No. 2006  
ATA Code 24-50

Kit No. 23-3011-1 S

**SUBJECT: ELECTRICAL POWER - INSTRUMENT PANEL GROUND STRAP INSTALLATION**

## Service Bulletin No. 2006

Figure 1

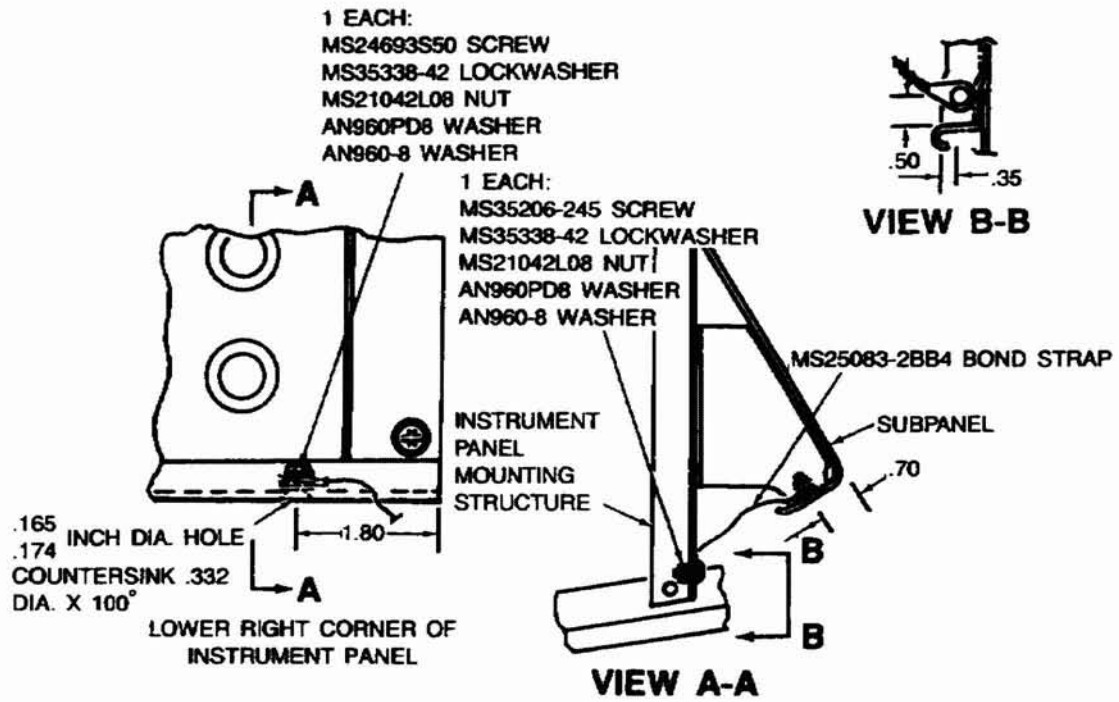
4. On the lower right hand corner of the instrument subpanel, drill a .165 to .175 inch diameter hole in the bottom lip. Countersink the hole to .332 inch diameter with a 100 degree countersink. (see Figure 1)

6. On the lower right hand instrument panel mounting structure, drill a .165 to .174 inch diameter hole just above the "J" stringer as depicted in Figure 1, views A-A and B-B. Clean the area per step 5.

9. Insulate the bond strap with P/N 106242C2 heat shrink tubing or equivalent and a heat gun. Install the free end of the bond strap at the newly drilled location on the instrument panel mounting structure using a P/N MS35206-245 screw, a P/N AN960PD8 washer under the terminal lug, a P/N AN960-8 washer, a P/N MS35338-42 lockwasher and a P/N MS21042L08 nut. (see Figure 1 view A-A)

Figure 2

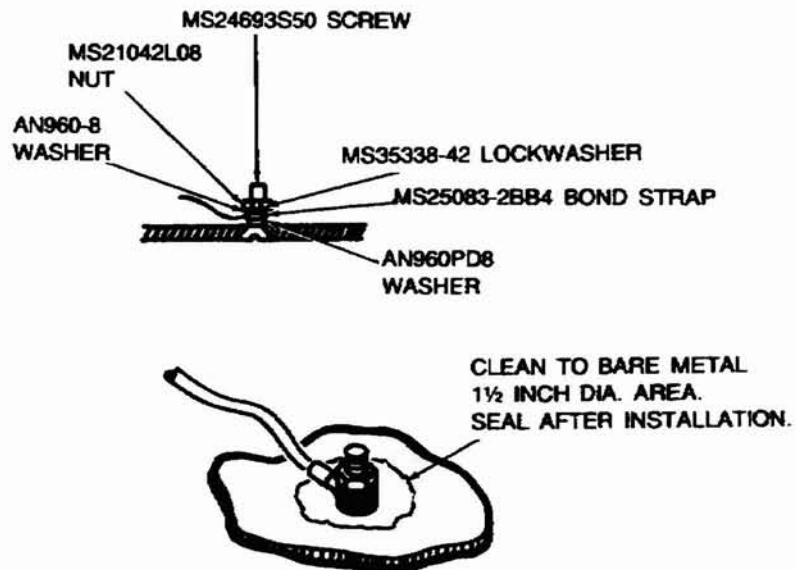
5. Refer to Figure 2 and clean a small area around the countersunk hole in the instrument subpanel to bare metal. Clean the bare metal with 1,1,1 Trichloroethane or equivalent (adequate ventilation required, obtain locally).

8. Attach a P/N MS25083-2BB4 bond strap at the hole on the lower right hand corner of the instrument subpanel using a P/N MS24693S50 screw, a P/N AN960PD8 washer under the bond strap terminal, a P/N AN960-8 washer, and a P/N MS35338-42 lockwasher between the P/N MS21042L08 nut and the bond strap terminal lug. (see Figure 2)
